Addendum #1

DND LOCKERS/SHOWERS RENOVATION

Project No. R.042799.002

DATE: September 07, 2012

3. Drawing 9/A301

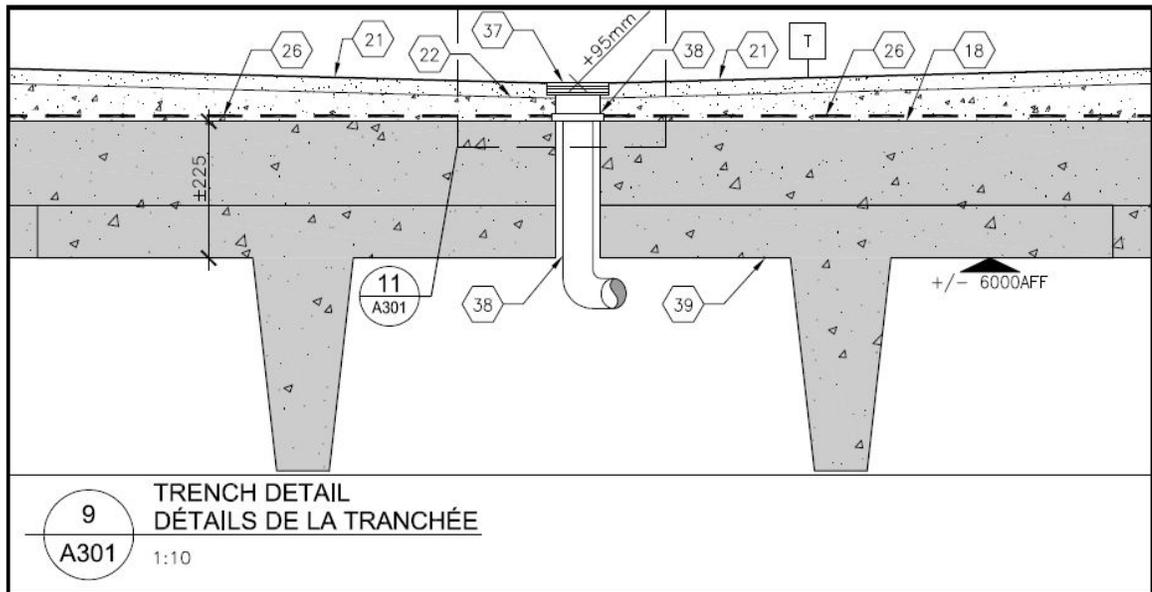
- .1 **ADD** new dimension to slab as shown below:
